QUEENSTOWN AQUATIC CENTRE FAST SLIDE

[REDACTED] has been engaged to review the design and operation of the waterslide known as the fast slide at the Queenstown Aquatic Centre, in response to a significant number of reported injuries resulting from patrons tipping or rolling in the slide.

Image 4. Showing the significant component of transverse travel of the water in the slide, in the section between the bend (a15) and the runout. This is again the result of the combination of steep slide gradient and a short radius bend.

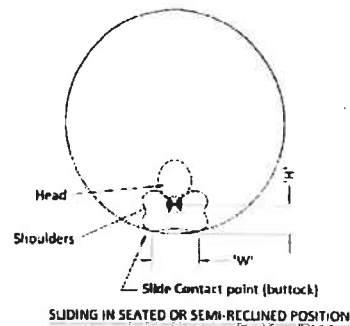
Examination of the photograph (Image 4) of flow patterns at the slide exit indicates that the flow path is considerably longer than slide invert, and an increase of path length of 8-10% could be involved. Coupled with the influence of turbulence, and an effective reduction in slide slope (10% due to the extra length) effective velocity of the flow could be as indicated in Table 3 below.
